## Voltage Regulator Wire Interference – 1990 Mariner/Mercury 135-200

Figure 1. Wire / Screw Interface

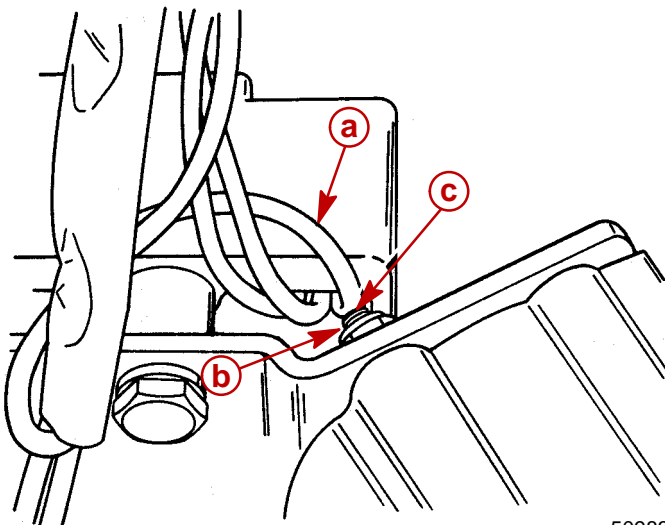
Tachometer wire which exits the voltage regulator case may contact the ignition coil mounting screw (Figure 1) on some outboards. Wire contacts with screw end may destroy wire insulation and eventually prevent tachometer from operating.

Check for wire and screw interference.

Move wire away from screw.

Apply a drop of silicone sealer between wire and screw (Figure 1).

Figure 2. Voltage Regulator with 0190 Date Code

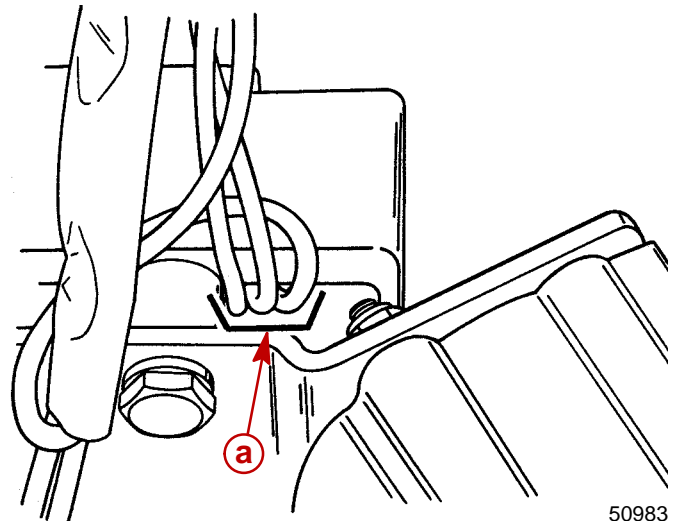
Voltage regulators produced after 1/19/90 (Julian date code 0190 printed on the housing) have the wire exit changed. These voltage regulators have the wires moved inward from the corner to an area next to the mounting hole (Figure 2).
